Report: TAB Report
Function: Test, Adjust, & Balance
Date: 01/28/2026
Completed By: National TAB

02-16-26 WHATABURGER #1687 LUTZ, FL

Table Of Contents

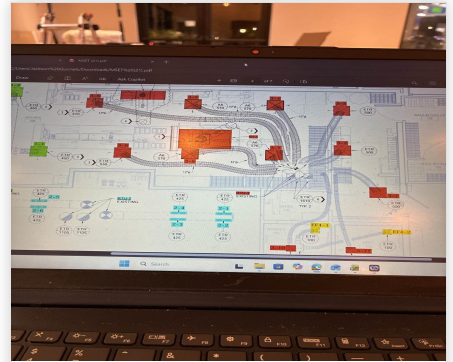
Issue Name : Exhaust fans - Incorrect Locations
Description : Exhaust fans are mounted on wrong curbs. Unable to balance fans in current state. EF-1 (larger fan) also leaks around curb.
Created By : National TAB **Assigned To :** National TAB - Will Turnbough
Status : Open
Priority : Urgent **Asset Tag :**
Originated Date : 02/19/2026 - Jackson Gunnels - National TAB

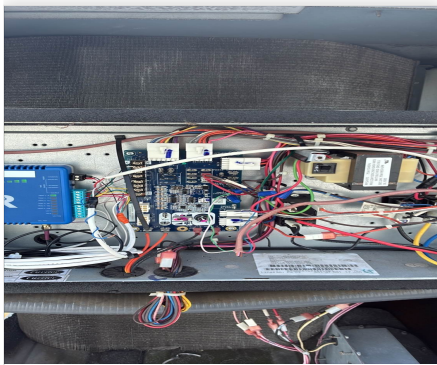
Issue Name : Restroom supply dampers
Description : Parallel blade dampers installed in restroom supply only reduce airflow by half when fully closed, recommend OBDs be installed.
Created By : National TAB **Assigned To :** National TAB - Will Turnbough
Status : Open
Priority : Urgent **Asset Tag :**
Originated Date : 02/19/2026 - Jackson Gunnels - National TAB

Screenshot of the GRD marked up with supply and return traverse locations for RTU-1 (Add picture here)

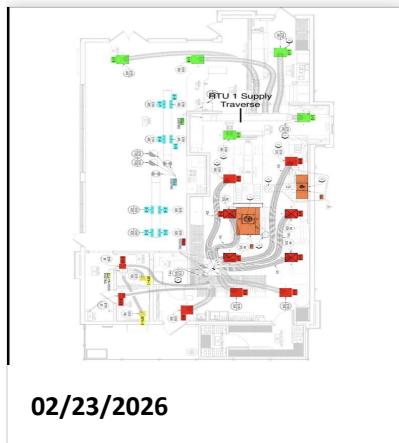
Return traverse not possible.

Asset: RTU-1

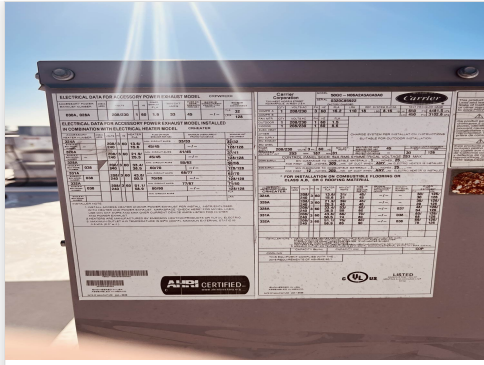
*Unable to traverse return

Asset: RTU-3

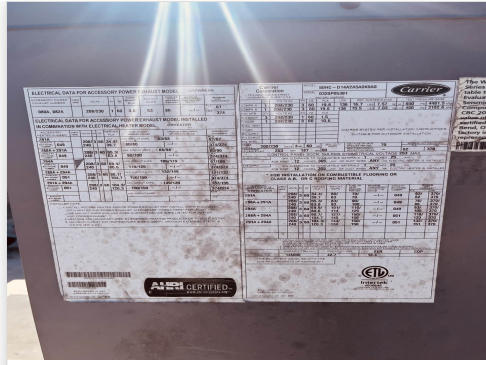
Notes:
Fan sheave sits further out than motor sheave
